**STAFF MEMORANDUM
HISTORIC PRESERVATION PROGRAM
PLANNING AND URBAN DEVELOPMENT**

TO: Chair Pollard and Members of the Historic Preservation Board
FROM: Evan R. Schueckler, Historic Preservation Program Manager
DATE: September 30, 2022
RE: 51 Valley Street (Western Promenade) – First Workshop– New Construction, Gazebo
PROJECT ID: HPBR-002214-2022
MEETING: October 5, 2022

Historic Preservation Commission Workshop Submission

WESTERN PROMENADE GAZEBO

1	PROPOSED FIRST FLOOR PLAN
A100	1/4" = 1'-0"

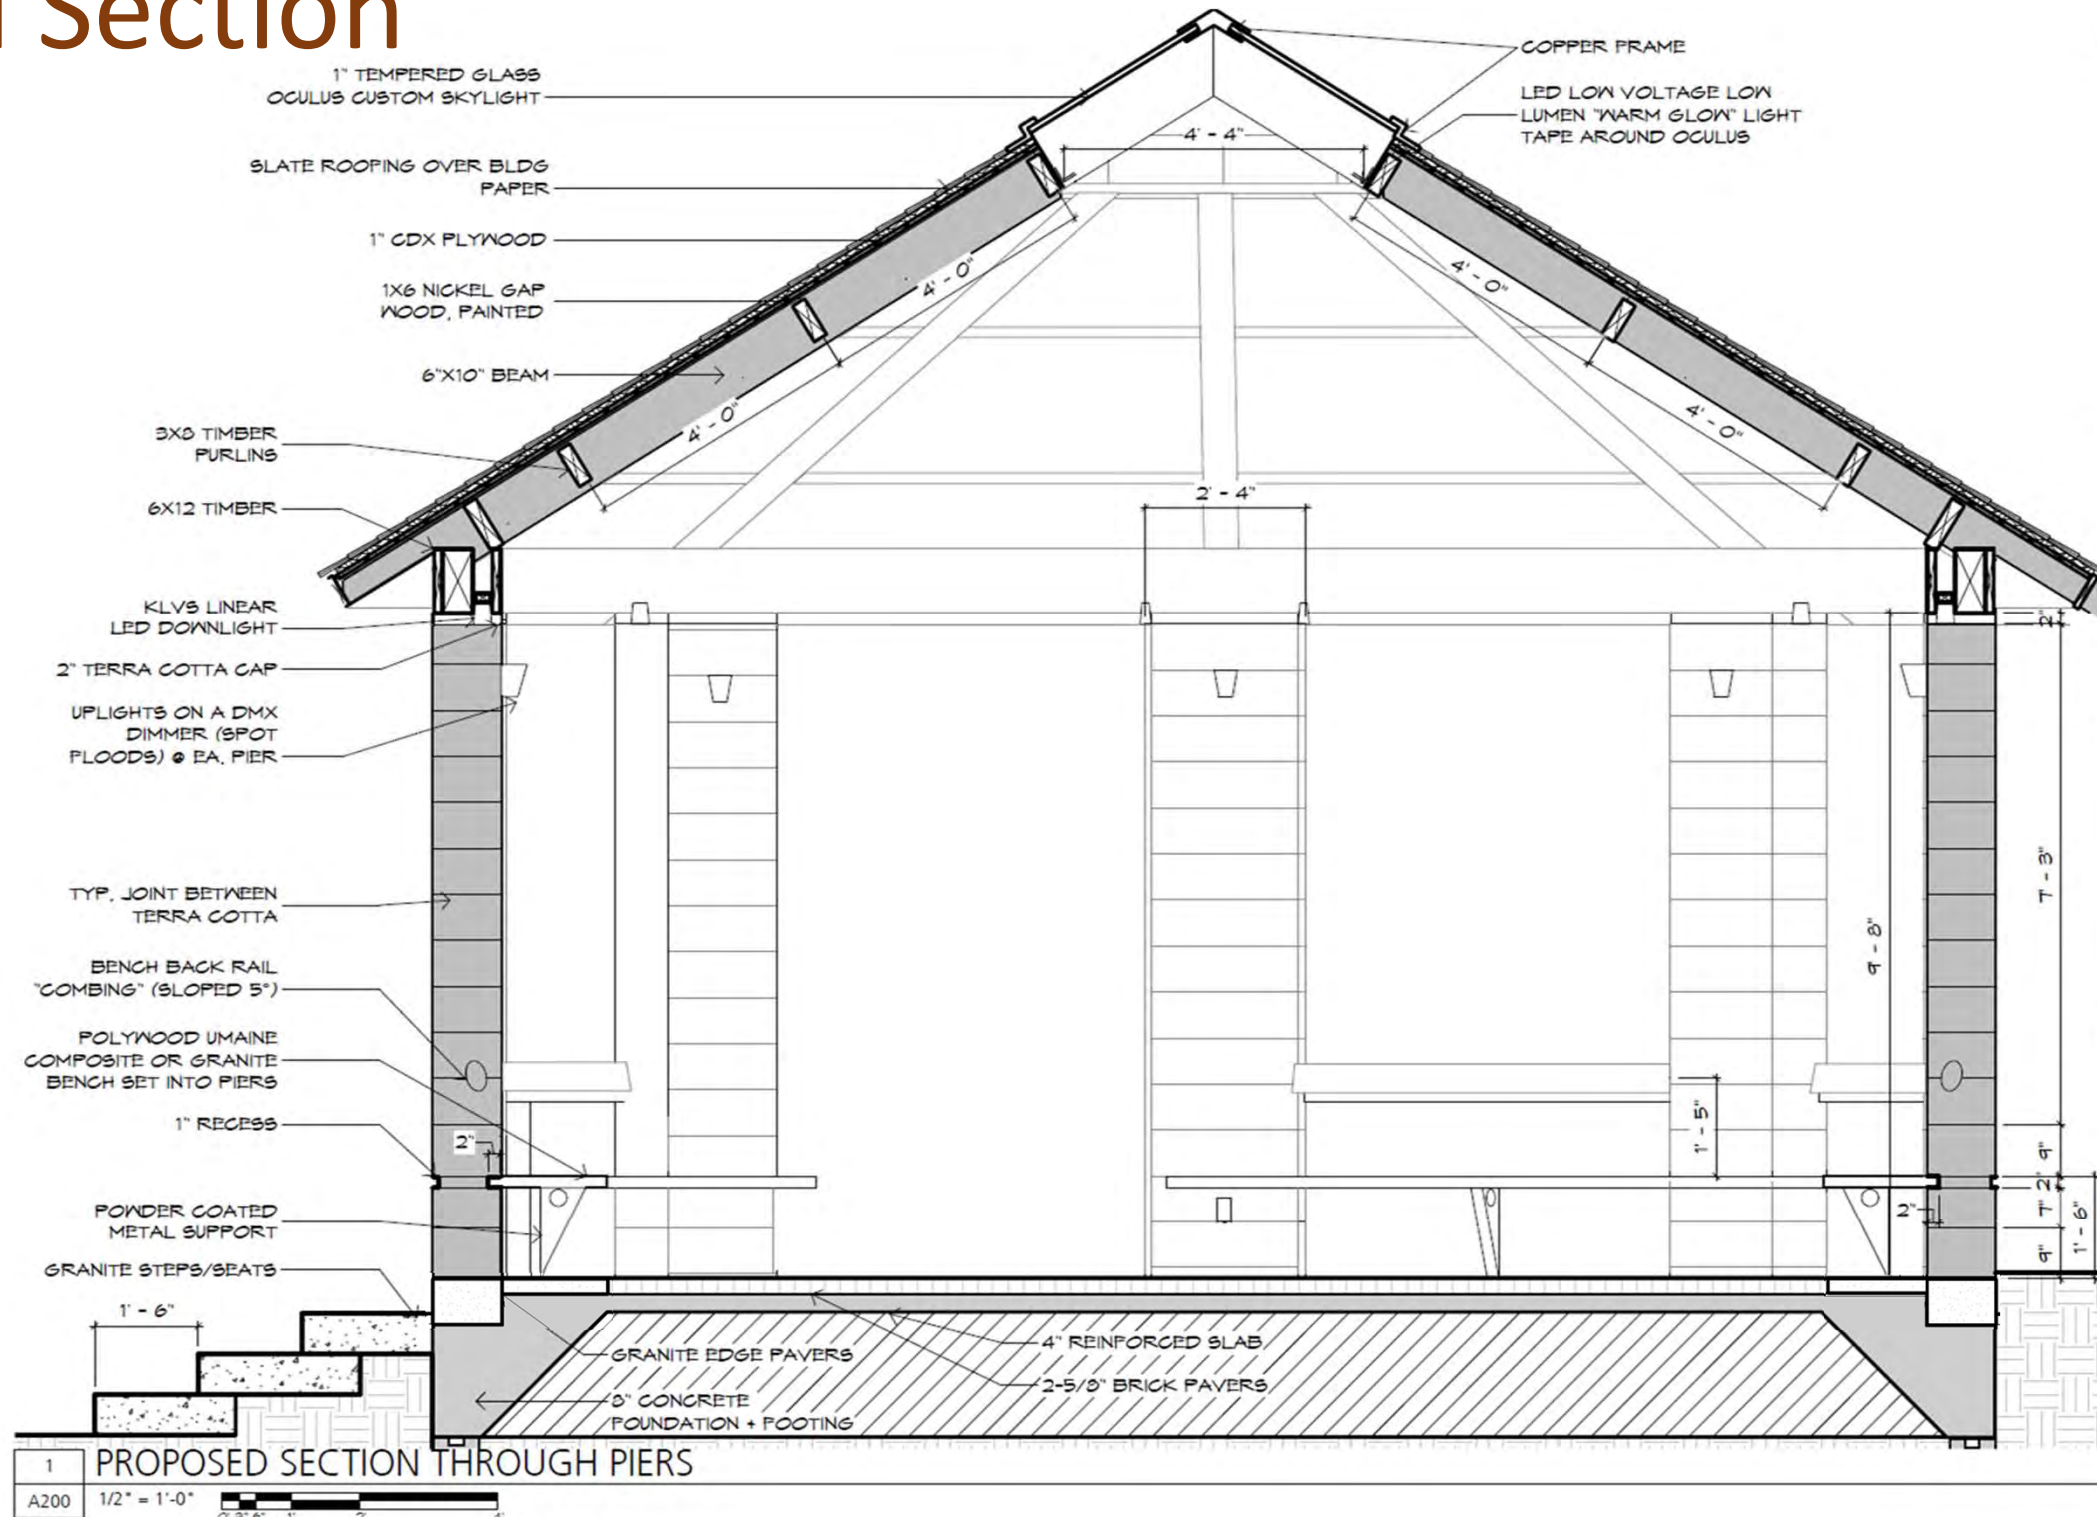
The design as presented follows the same idea of matching the geometry of the original gazebo with a round base and octagonal roof. The base is framed by eight curved column supports over a round stone foundation, with each column aligning with a hip in the roof. The proposed floor of the gazebo would be entered through two at-grade entrances to the north- and south-east to align with the historic sidewalks that led to the gazebo. The design still includes a series of deep steps cascading three or four tiers down from the west side of the gazebo. However, the design team has been exploring several departures and refinements from the master plans schematic design.

One of these has been to incorporate an additional detail from the Stevens & Cobb design in the form of the “wing walls” that originally framed the entry stairs. In the proposed design, a single wing wall to the west side of the two at-grade entrances would be included to provide a welcoming feature to the gazebo, inviting people in from the path.

Additionally, the schematic design had shown seating being incorporated only on the east side of the pavilion, and using what appear to be pre-fabricated benches. The design team and oversight committee have been discussing using integral benches and incorporating them in the eastern and western halves of the gazebo. Currently, the proposal would be for the benches seats to tie into the column supports and have simple backrest elements that span between the columns allowing occupants to face into or out of the pavilion. While the oversight committee feels there's great potential in an integral bench design, cost estimation will include an alternate for an "off-the-shelf bench" as a potential cost savings for the project.

1 PROPOSED REFLECTED CEILING PLAN
A300 1/4" = 1'-0"

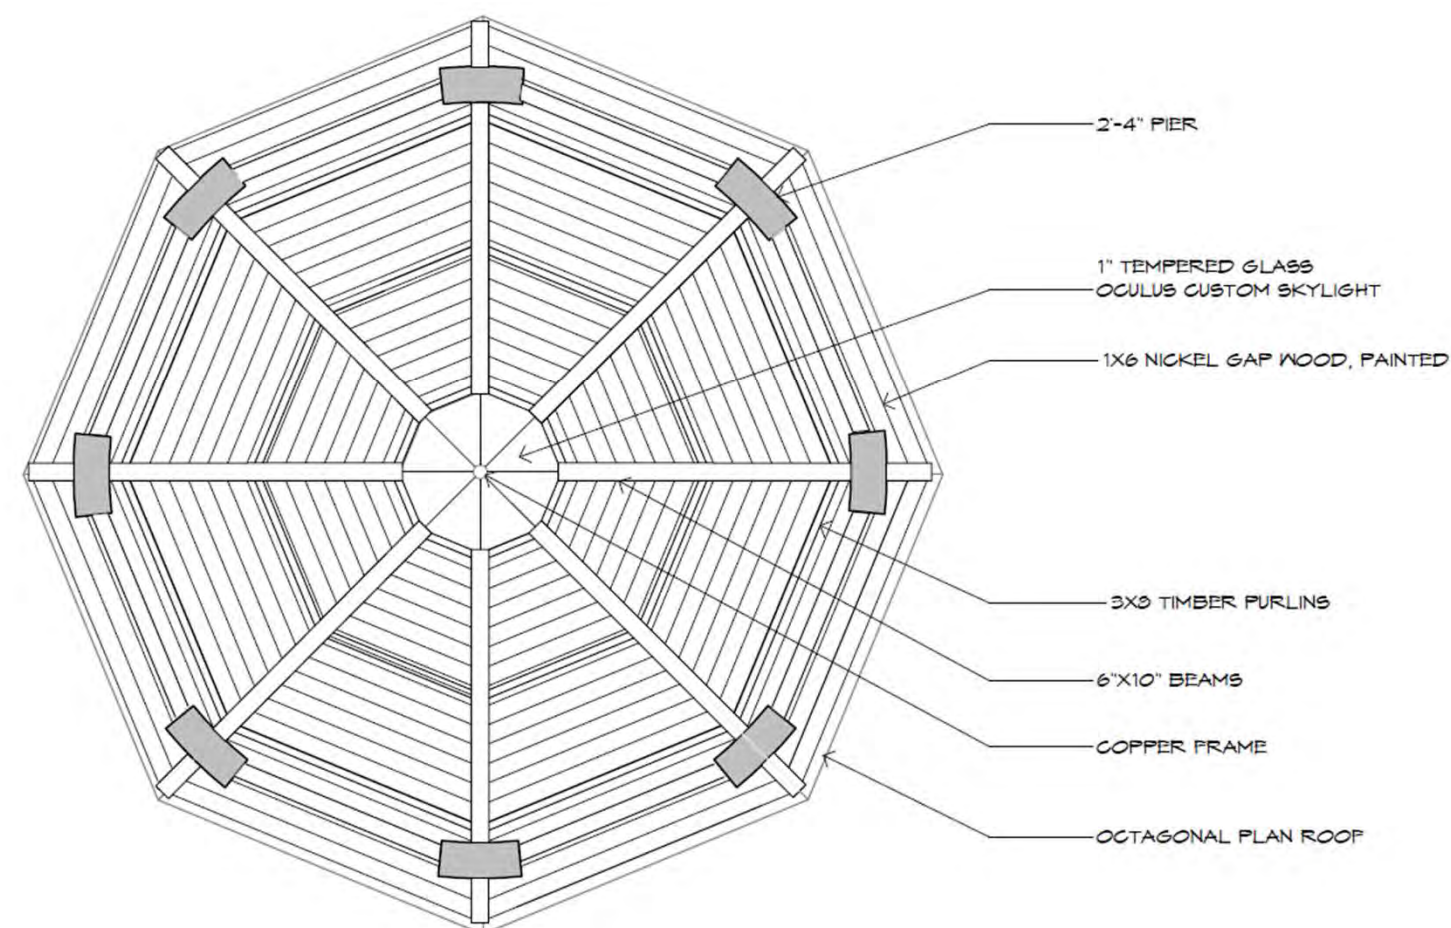
Another significant change has been to include an oculus in the roof of the gazebo to bring more daylight into the structure and add opportunities for night-time lighting. There is no evidence that the historic structure had such a feature, though it may have had a metal pinnacle as seen on the Eastern Promenade gazebo. While the proposed oculus would help to differentiate the historic gazebo from the new and make the structure brighter and more dynamic, the Board should weigh in on its appropriateness. Additionally, the Oversight Committee has some concerns about the cost implications of the feature and will have it included as an alternate in the cost estimate. The oculus may not be included in the final design even if the Board views the feature favorably.
